**Class 1 Permit Modification Notification**

**Revise Panel Figures To Include Panel 5  
Revise Firewater Distribution System Figures**

**Waste Isolation Pilot Plant  
Carlsbad, New Mexico**

**WIPP Permit Number NM4890139088-TSDF**

Figure F-3  
WIPP Underground Facilities

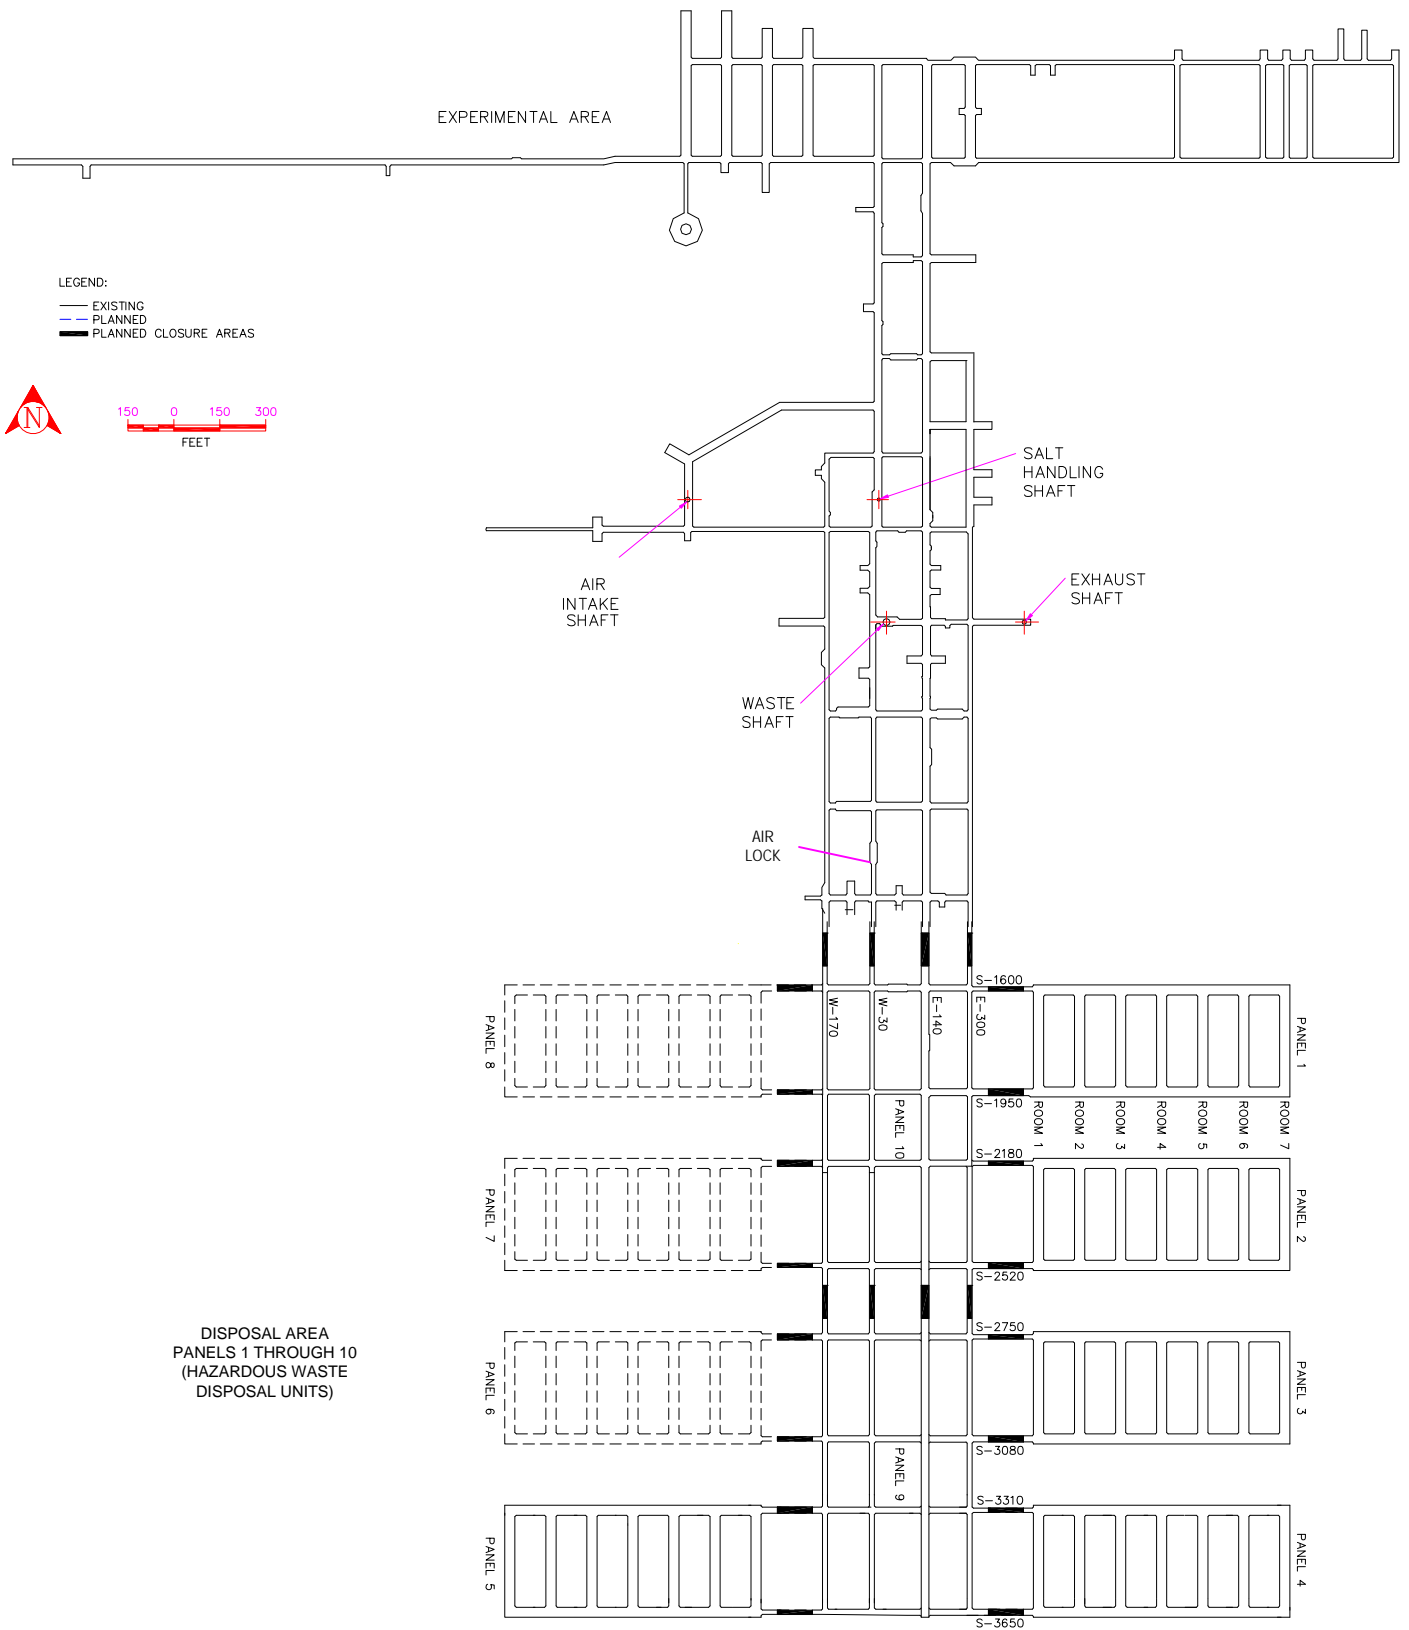
Revise figures in the Permit to indicate that Panel 5 has been approved by the NMED. The designation on the figures is being changed from “planned” to “existing” hazardous waste disposal unit (HWDU).

On December 17, 2008, the Permittees were notified by the NMED that Panel 5 had been constructed in compliance with the requirements in the Permit. Panel 5 has been certified in accordance with the Permit Condition I.E.II and is now available for waste emplacement. Figures F-3, F-5, F-9, I-1, I-6, I2-1, M2-1, N-1 and O3-2 have been revised to show that Panel 5 is now approved for waste emplacement. The change removes the “dashed” lines and replaces them with “solid” lines in order to change the designation from “planned” HWDU to “existing” HWDU.

Figure F-6  
Fire Water Distribution (cut away/clouded view)  
(For Informational Purposes Only)

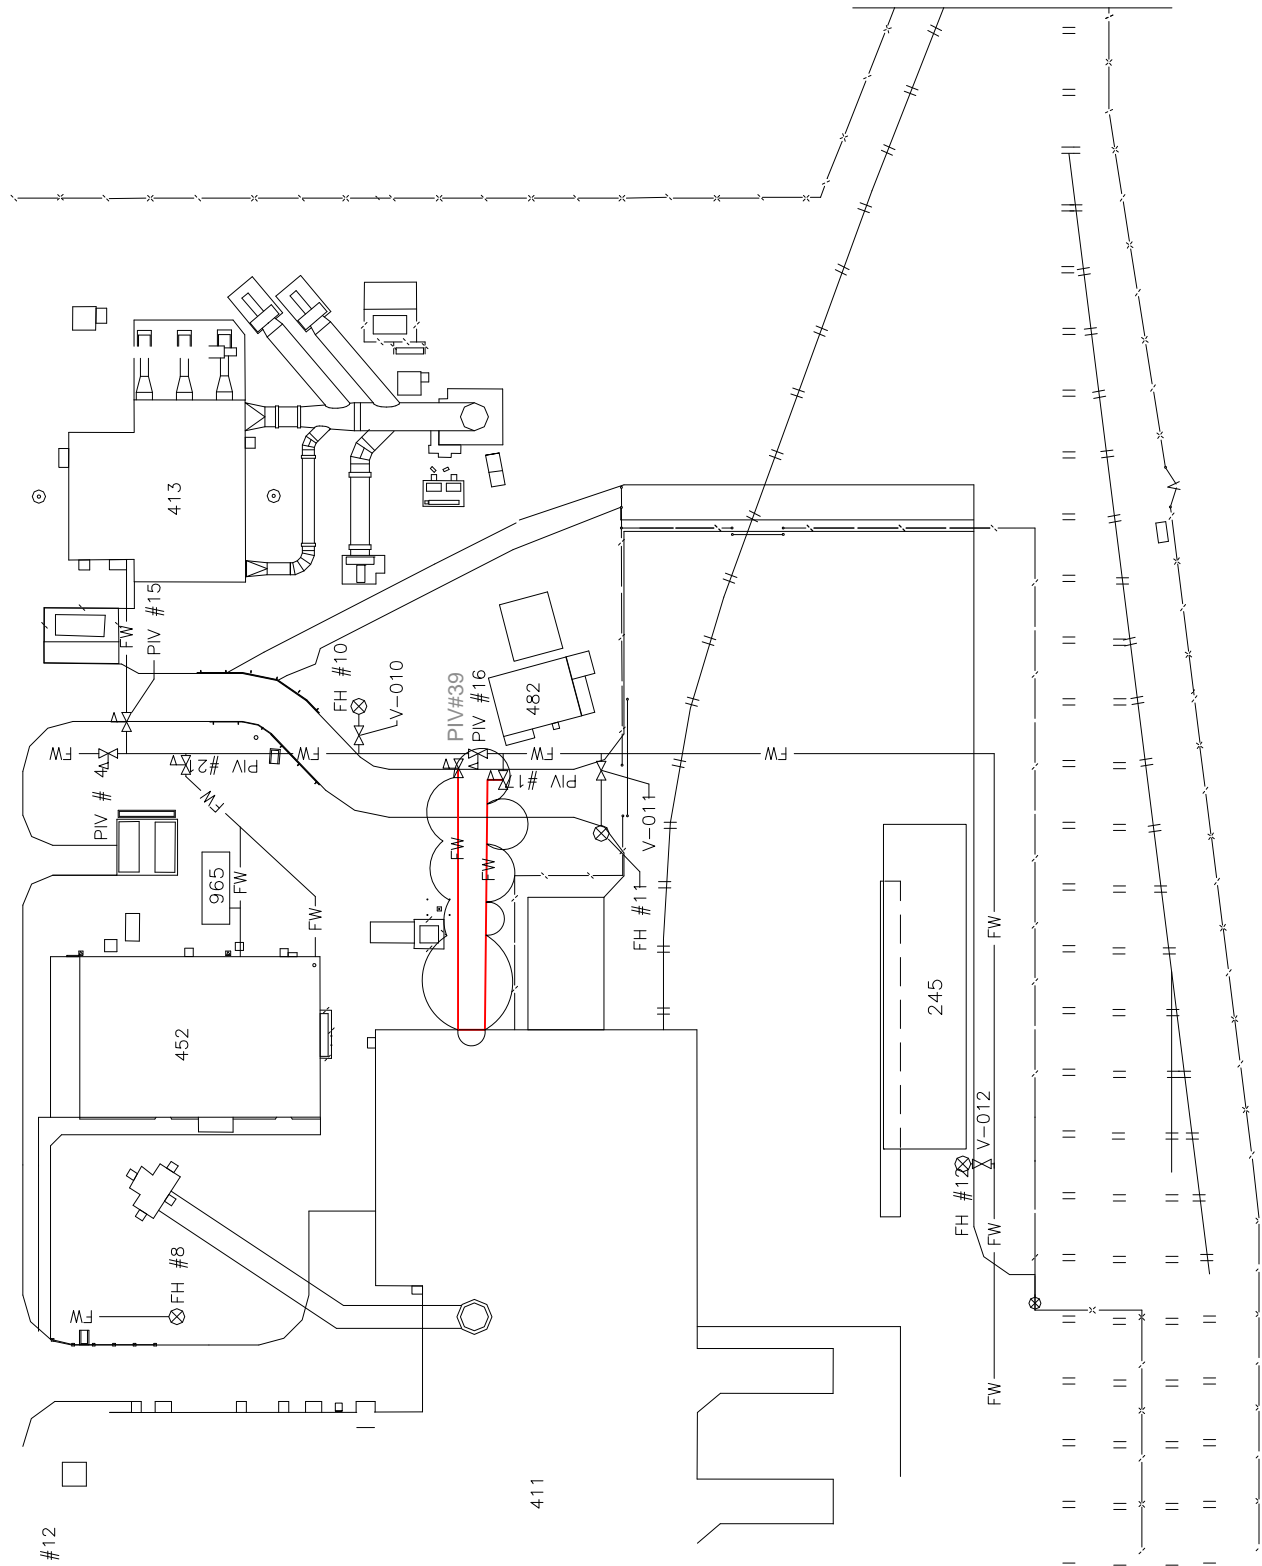
Revise figures in the Permit to include a new PIV that has been added to the fire water distribution system that serves the RH Bay in the WHB.

On November 20, 2008, the Permittees submitted a Notification of Planned Change to the Permitted Facility. In this Notification it was determined that a Class 1 Permit Notification would be required to revise Figures F-6, F-10, F-10a, F-11 and F-11a when the construction activities and certification were completed. The upgrade of the new fire water distribution system and the certification by a registered Professional Engineer is now complete. This modification updates all five figures to reflect the addition of the new PIV per the Notification of Planned Change.

Included with Figure F-6 are two figures. One is an expanded view of the affected area of the figure with a “cloud” around the new PIV for ease in determining where the change has been made. The other is a “clean” figure for insertion in the revised Permit. A “clouded” figure is not necessary for the remainder of the figures.
